Southern Nuclear Operating Company
Vogtle Electric Generating Plant Unit 3
Preliminary Amendment Request (PAR): Containment Internal Structural Module
Shear Stud Size and Spacing (PAR-12-001)

Preliminary Amendment Request (PAR-12-001): Shear Stud Size and Spacing

Licensing Document Pages - Proposed Markups

Figure 3.8.3-8 (Sheet 1 of 3)

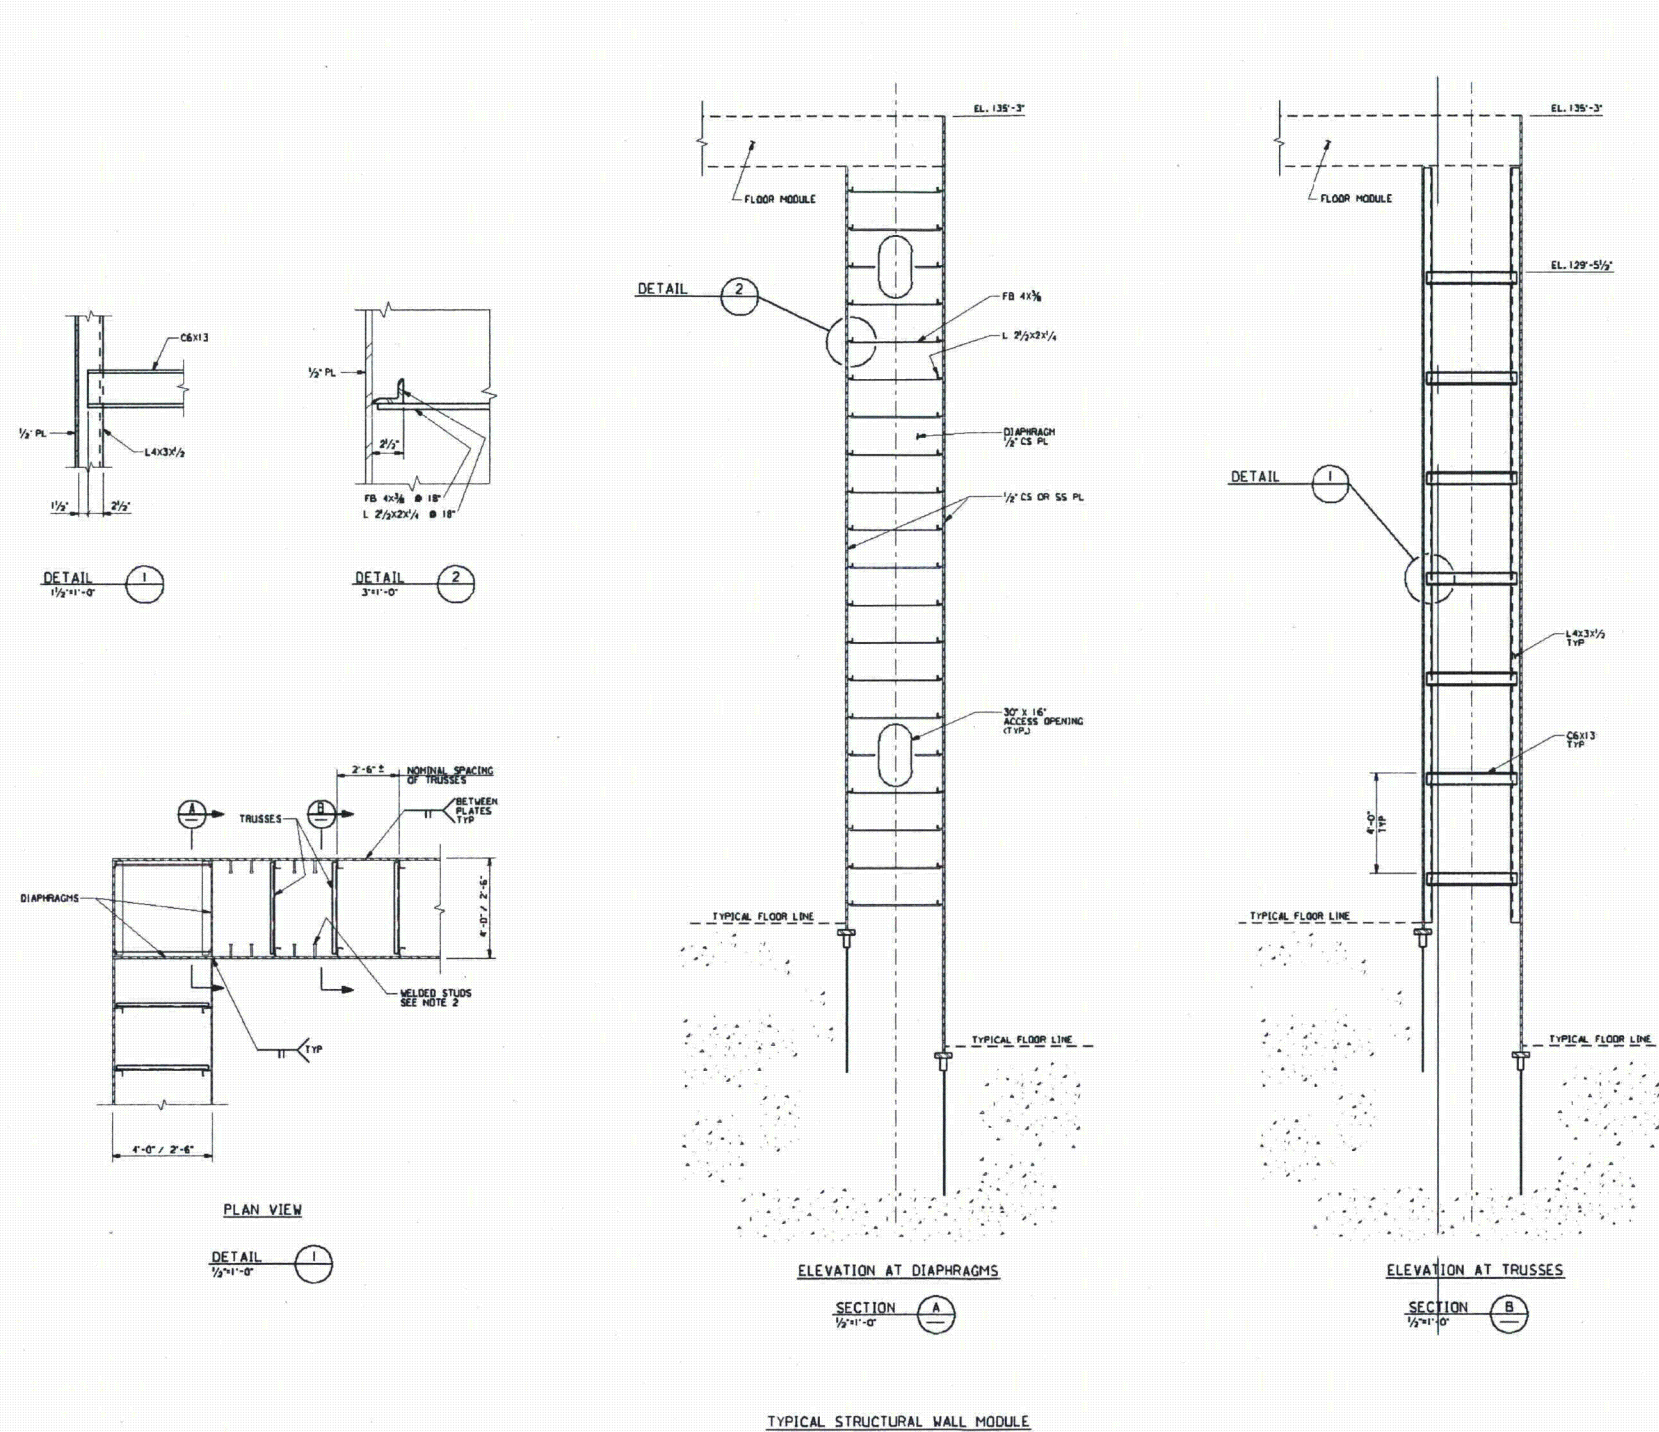
3. Brief Description of Proposed Change: Revise the structural module shear stud size and spacing requirements presented in plant-specific Design Control Document (DCD) Figure 3.8.3-8, Sheet 1, Note 2.

4. Reason for License Amendment Request: Design finalization of the containment internal structural modules identified that for procurement and fabrication reasons, the type of stainless steel material used for certain structural modules needed to be revised. Also, development and testing for the shear stud welding to the stainless steel plate identified the need to use a smaller stud diameter to provide a weld that would reliably satisfy inspection requirements. The combined impact of these two changes also required a change in the spacing of the shear studs. In addition, the spacing of the shear studs for the carbon steel plates was changed to be consistent with the design basis calculations. This change to the size and spacing of the shear studs is identified in Note 2 on plant-specific DCD Figure 3.8.3-8, Sheet 1. The minimum size and maximum design spacing of the shear studs on Figure 3.8.3-8 is designated as Tier 2* information; therefore, NRC approval is required in order to change it.

The proposed changes would amend Combined Licenses Nos. NPF-91 and NPF-92 for Vogtle Electric Generating Plant Units 3 and 4, respectively, in regard to the containment internal structural module stud size and spacing by increasing the carbon steel vertical stud spacing, decreasing the stainless steel stud diameter, and decreasing the stainless steel vertical and horizontal stud spacing in accordance with the design basis.
